Addendum 5 – UN Regulation No. 6

Revision 6 - Amendment 2

Supplement 27 to the 01 series of amendments – Date of entry into force: 10 October 2017

Uniform provisions concerning the approval of direction indicators for power-driven vehicles and their trailers

Annex 1, amend to read:

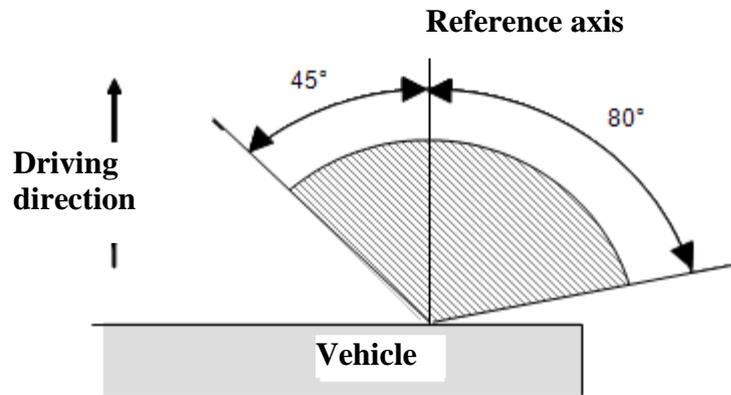
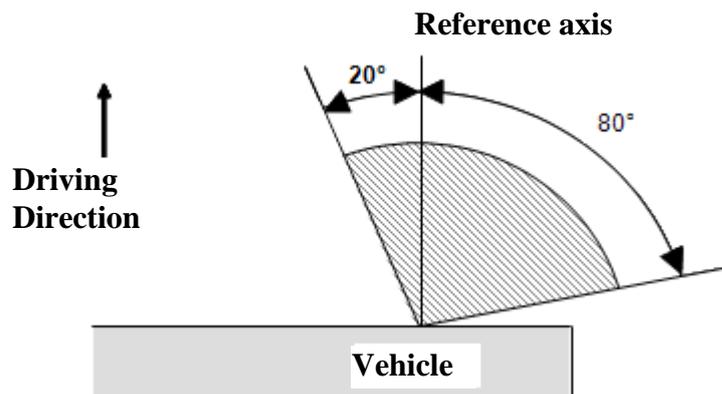
Category 1b: For use at a distance less than or equal to 20 mm from the dipped-beam headlamp and/or the front fog lamp.

Under the H plane for lamps intended to be installed with this plane at a mounting height less than 750 mm above ground

H plane: "horizontal plane going through the reference centre of the lamp"
